Technical Service Bulletin: tsb101811

Crankcase Vent Hose Modification for Cold Weather

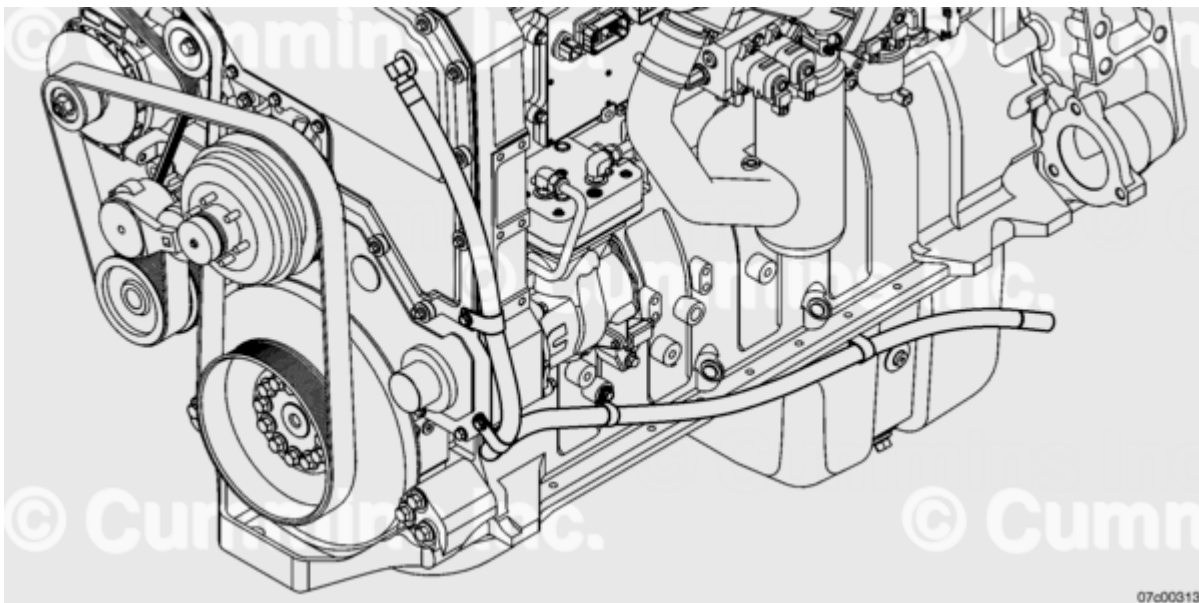
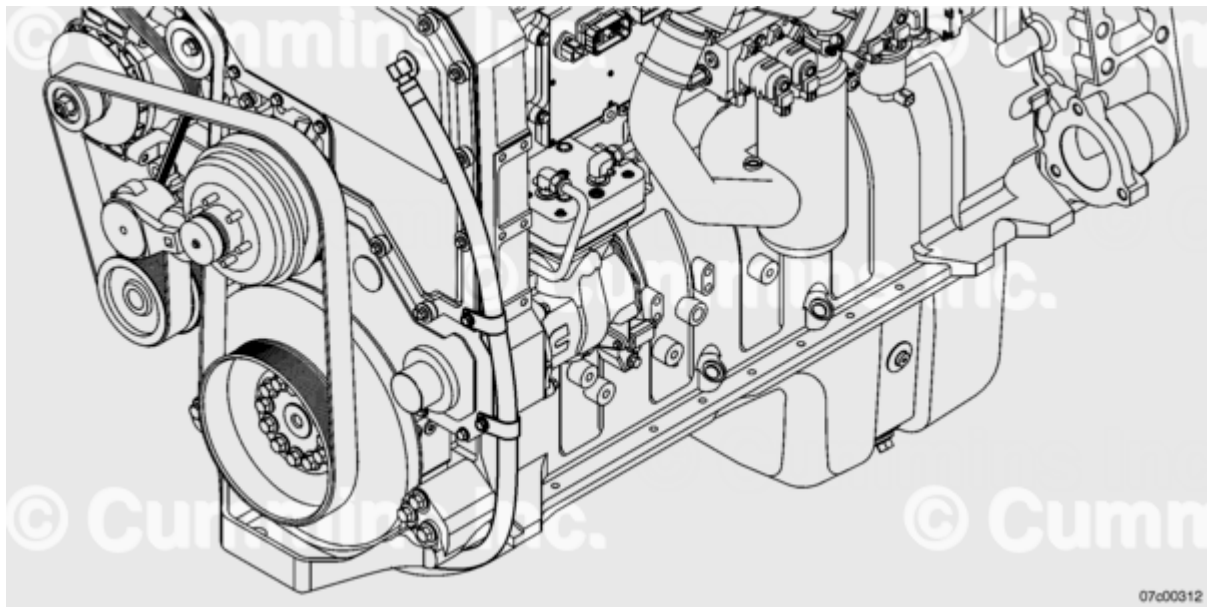
This Service/Parts Topic announces a modification to the crankcase vent hose on Signature, ISX, and QSX15 engines operating in cold weather. This modification can be made to any vehicles that may be operating in ambient temperatures from -23°C [-10°F] and below.

The following illustration shows the basic routing of the original crankcase vent hose.

The approximate length of the crankcase vent hose ranged from 168 cm [66 in] to 112 cm [44 in] in length.

The illustration below shows the new routing for the crankcase vent hose.
